DRAWING REVISION NOTES:
SHEET 2 OF SDP-99-054 (COLUMBIA GATEWAY) HAS BEEN REVISED TO PRESENT THE PROPOSED ENTRY & EMPLOYEE LOUNGE SPACE DESIGNS. THE PROVIDED LEGEND CLARIFIES THE SYMBOLS UTILIZED ON THE DEVELOPMENT PLAN. THE PLAN ILLUSTRATES THAT 11 TREES WILL BE REMOVED & 25 WILL BE PLANTED. THE EXISTING BOLLARDS WILL BE REMOVED & 16 NEW BOLLARDS WILL BE INSTALLED. A PAVILION, RETAINING WALL & HARDSCAPE WILL BE ADDED TO THE EMPLOYEE LOUNGE WHILE AREAS OF PLANTING WILL BE ADDED IN PLACE OF HARDSCAPE AT THE ENTRY AS WELL AS 3 FLAGPOLES & 12 POST LIGHTS.

SITE DEVELOPMENT PLAN
COLUMBIA GATEWAY
Parcels T-1, T-2, T-4 and T-5
Plat # 13402 thru 13404 & Plat No. 18716

SDP 99-54

Scale, Zoning, Date, Tax Map No., Sheet information. SCALE: AS SHOWN. ZONING: M-1. DATE: NOVEMBER 1998. TAX MAP No.: 43-1,2,7,8. SHEET: 9 of 22.

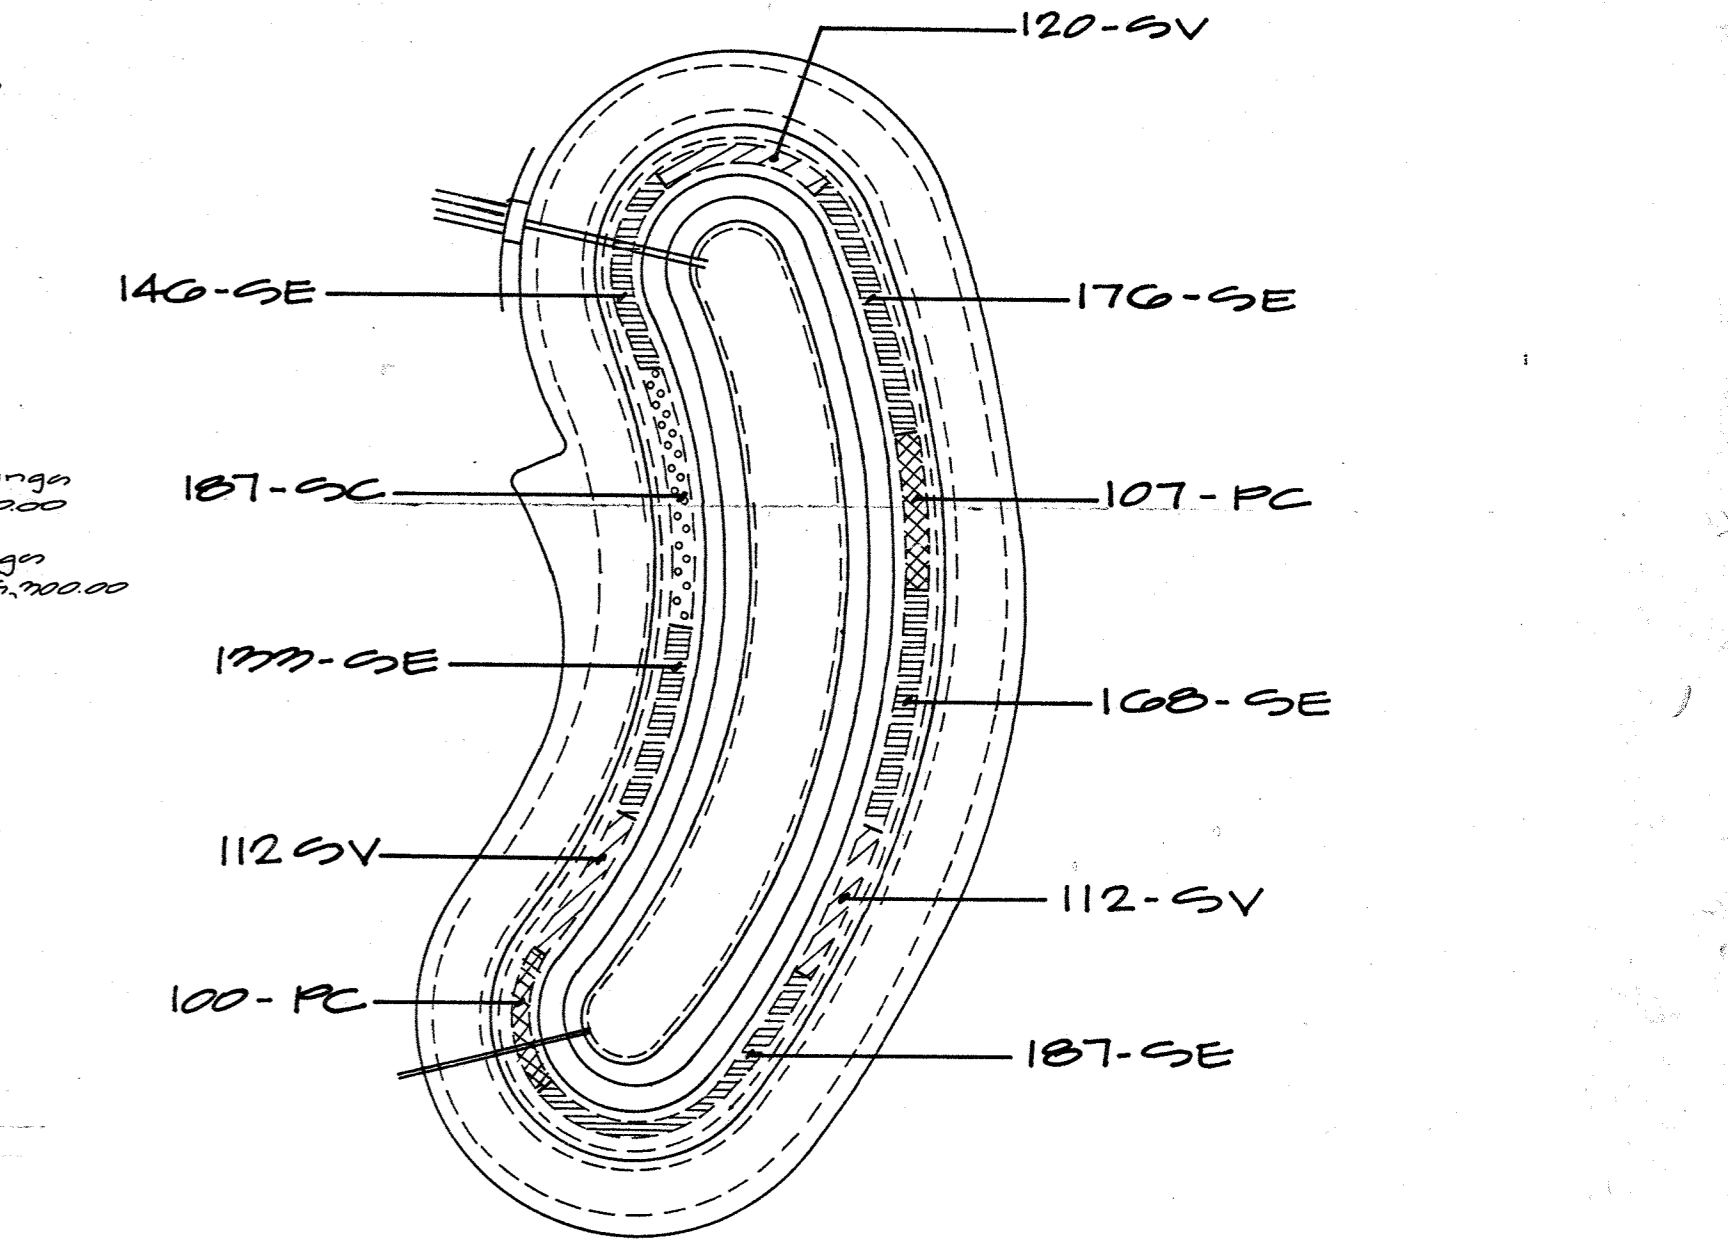
DRAWING REVISION NOTES: SHEET 9 OF SDP-99-154 (COLUMBIA GATEWAY) HAS BEEN REVISED TO ACCURATELY REFLECT THE TREE QUANTITIES FOR THE PROPOSED DESIGN. THE PLANT LIST ILLUSTRATES THAT 11 TREES WILL BE REMOVED & 25 WILL BE PLANTED.

SCALE	ZONING	G. L. W. FILE No.
1" = 30'	M-1	98067
DATE	TAX MAP - GRID	SHEET
Nov, 1998	43 1,2,7,8	17 of 22

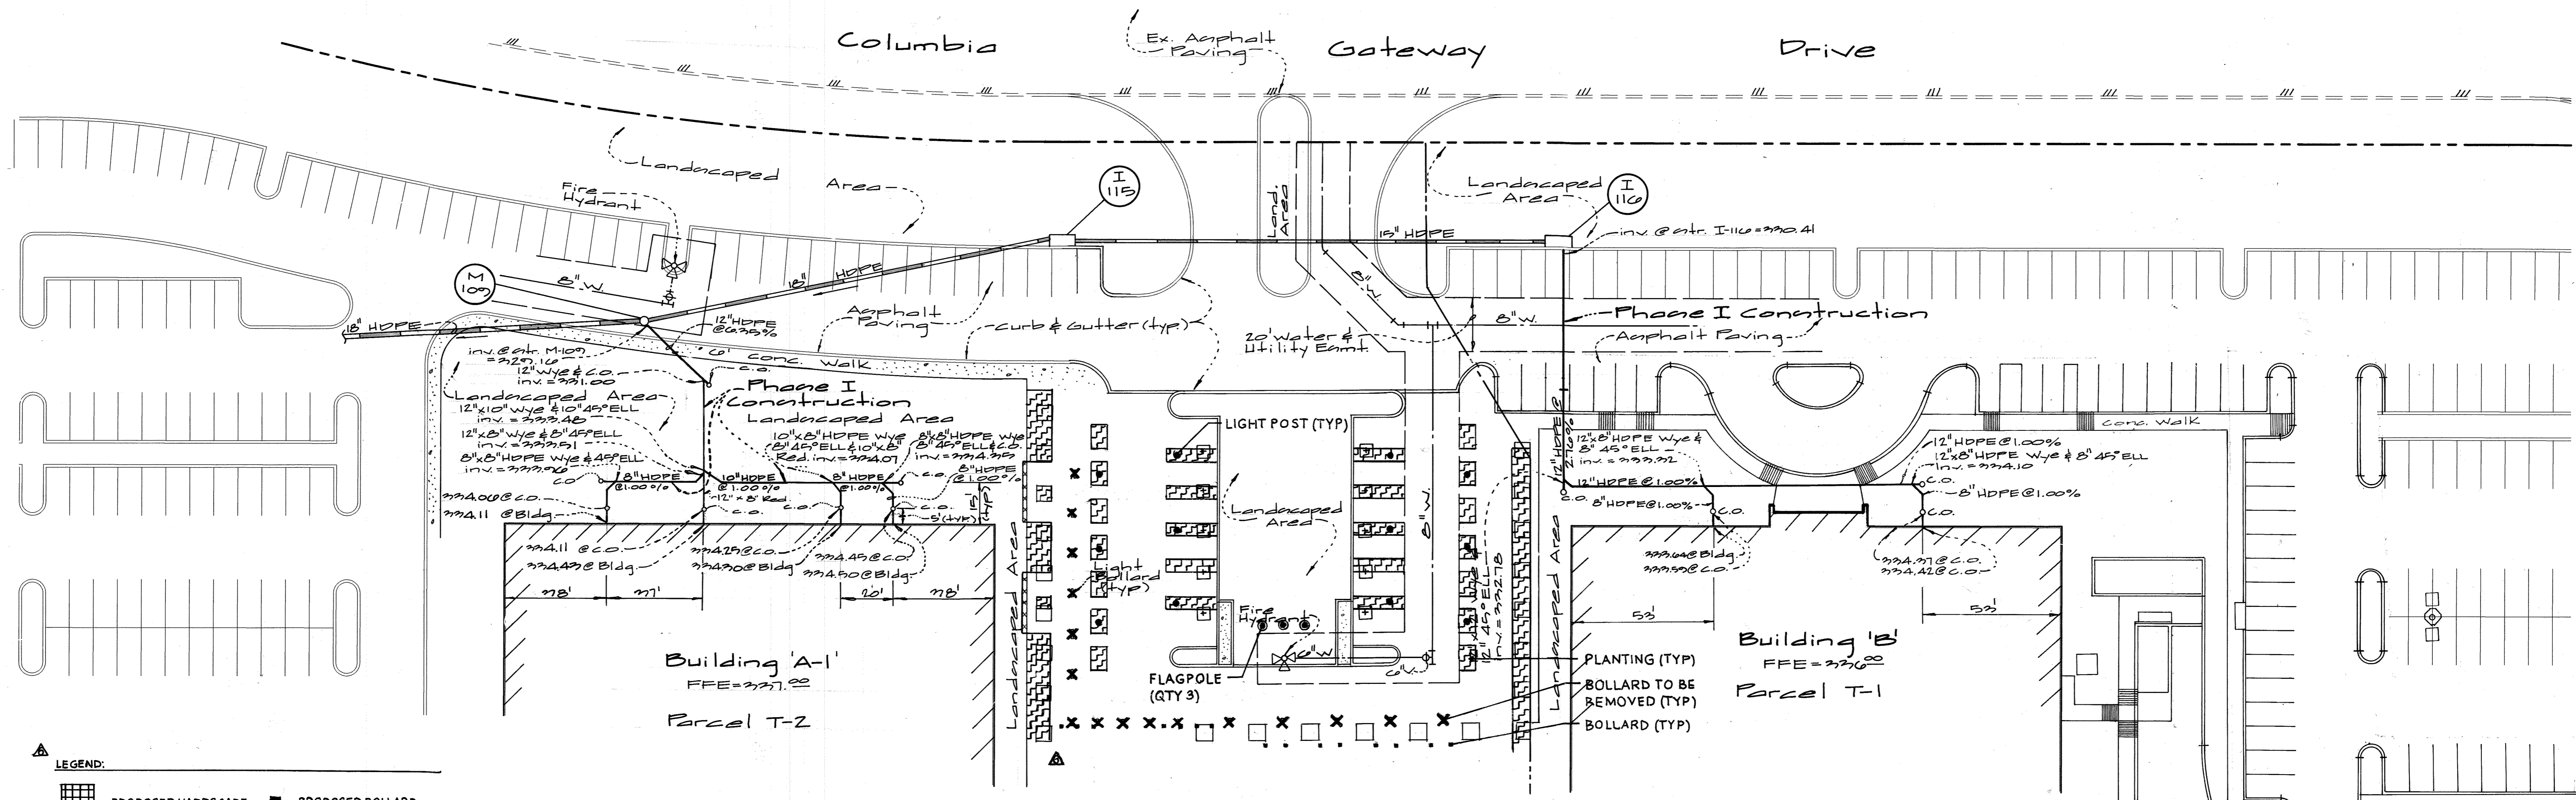
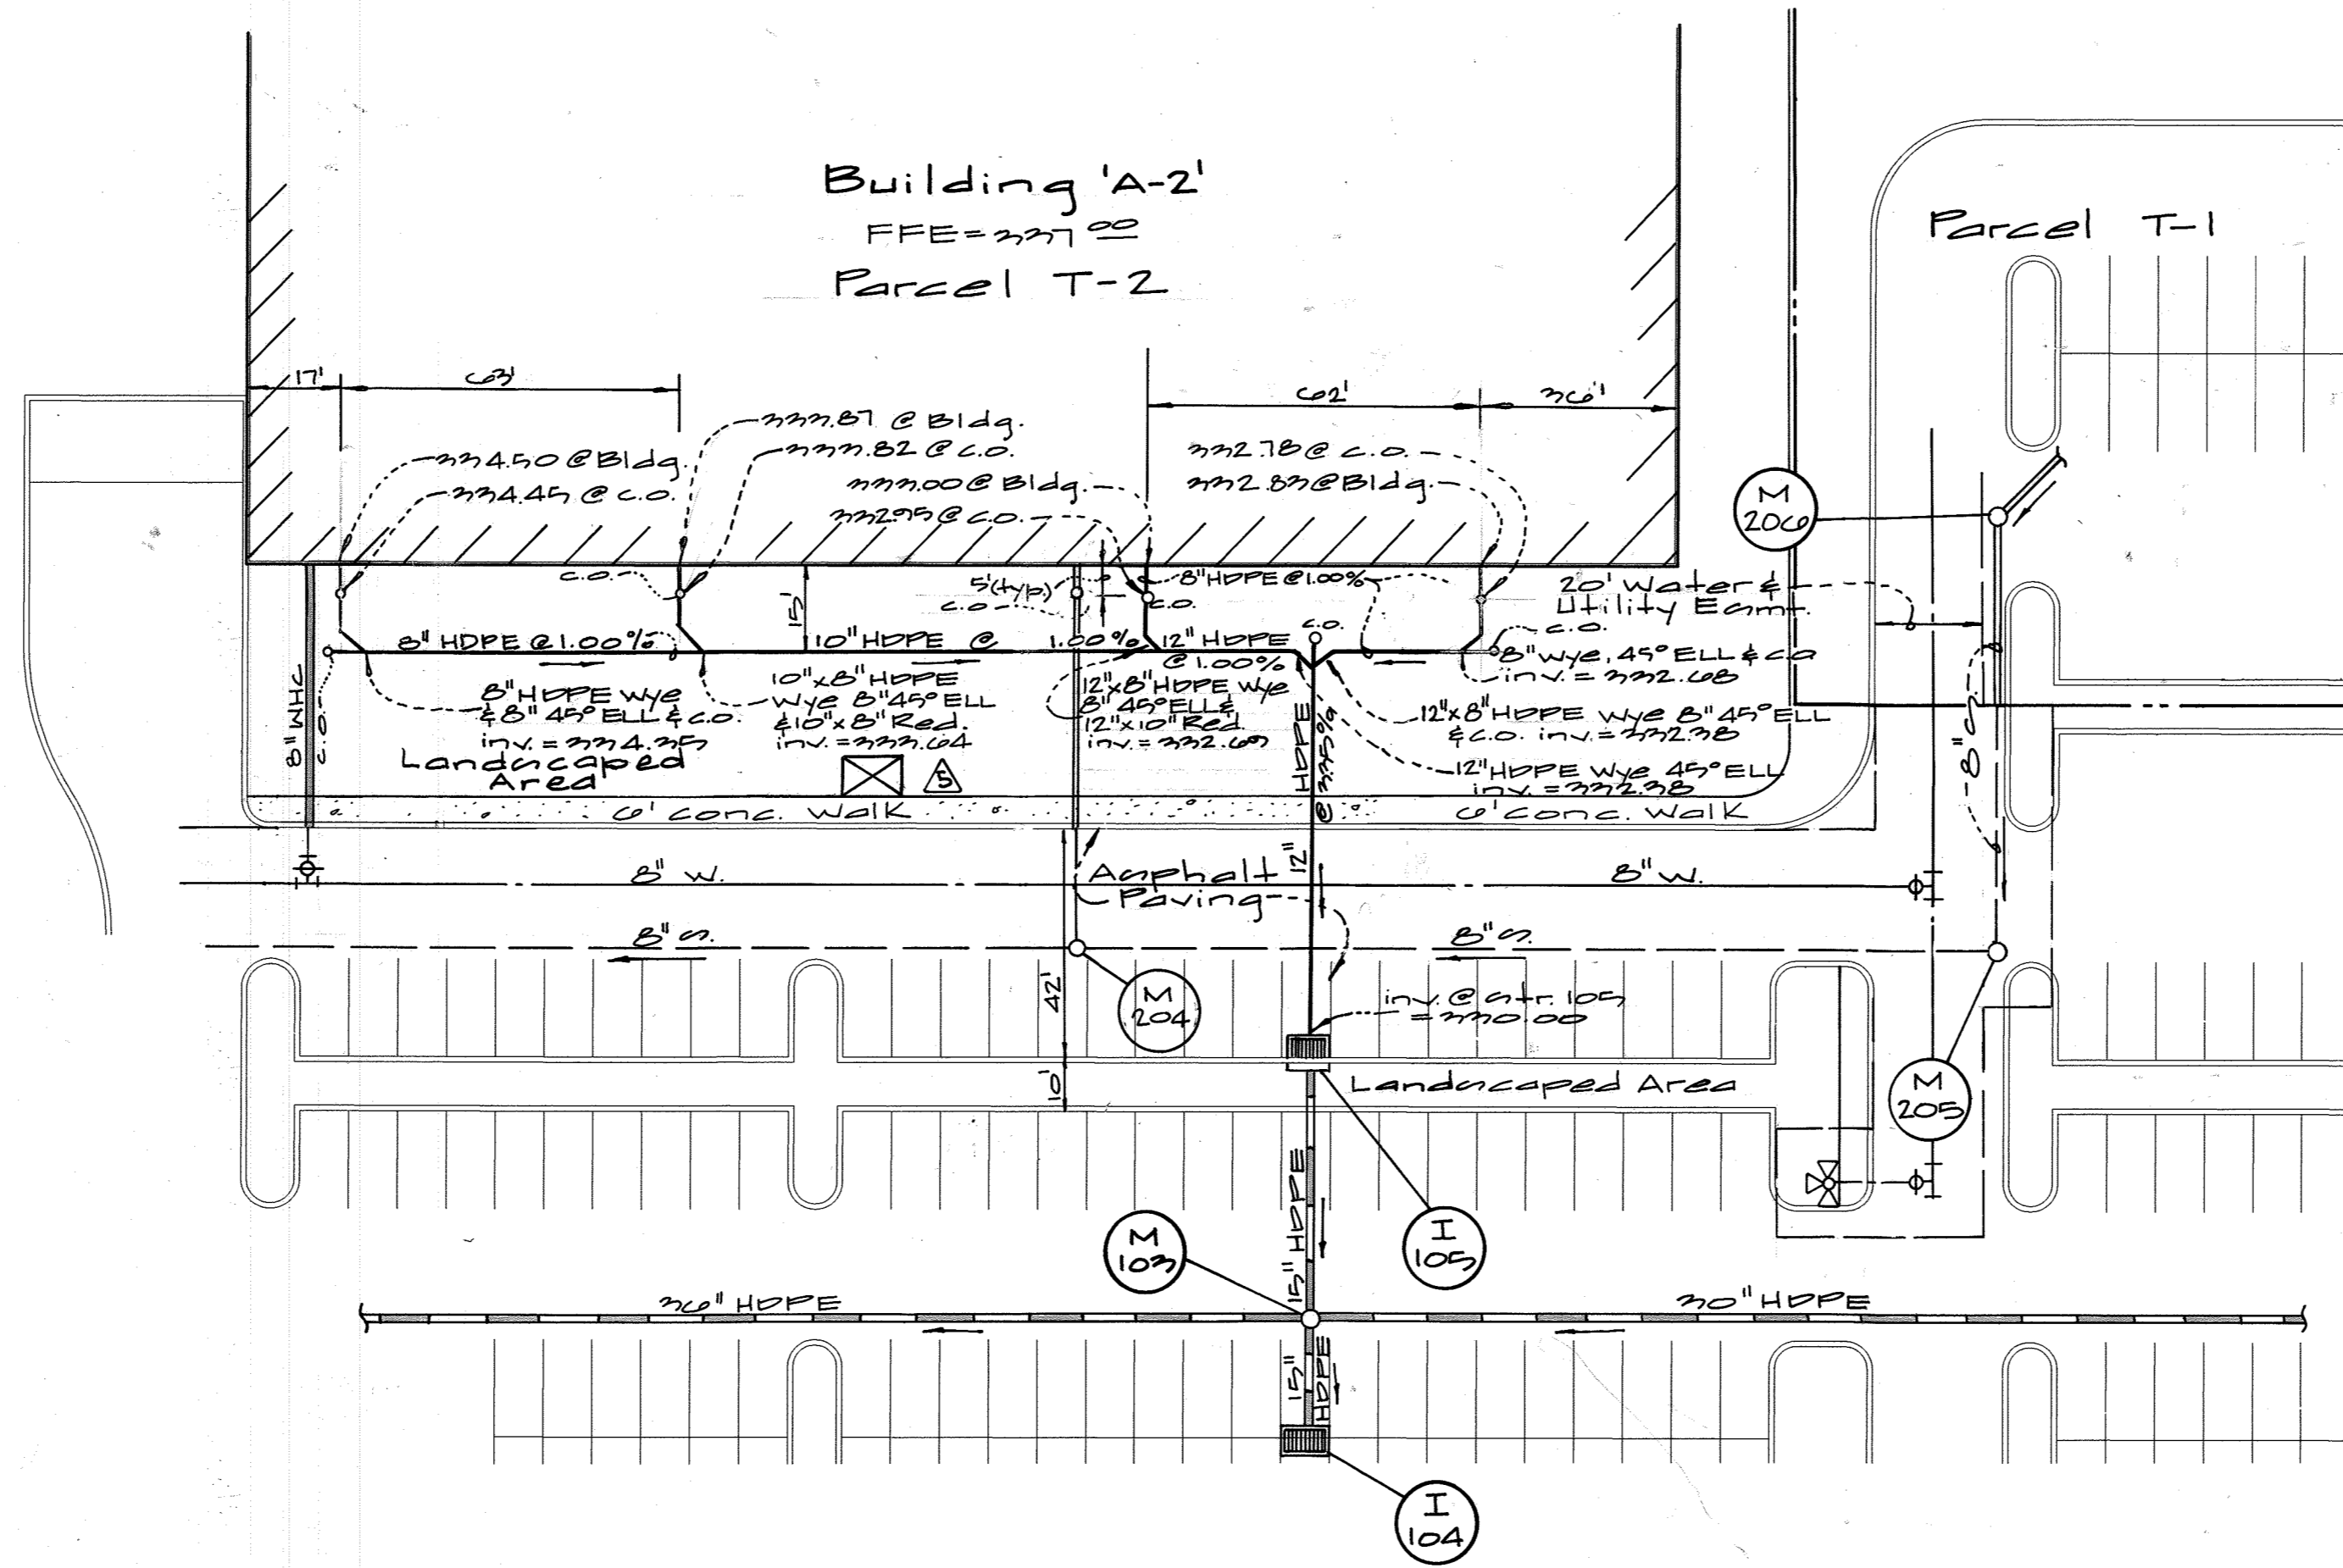
DRAWING REVISION NOTES:
 SHEET 19 OF SDP-99-054 (COLUMBIA GATEWAY) HAS BEEN REVISED TO PRESENT THE PROPOSED ENTRY DESIGN. THE PROVIDED LEGEND CLARIFIES THE SYMBOLS UTILIZED ON THE STORM DRAIN MANIFOLD PLAN. THE PLAN ILLUSTRATES THAT THE EXISTING BOLLARDS WILL BE REMOVED & 16 NEW BOLLARDS WILL BE INSTALLED. AREAS OF PLANTING WILL BE ADDED IN PLACE OF HARDSCAPE AT THE ENTRY AS WELL AS 9 FLAGPOLES & 12 POST LIGHTS.
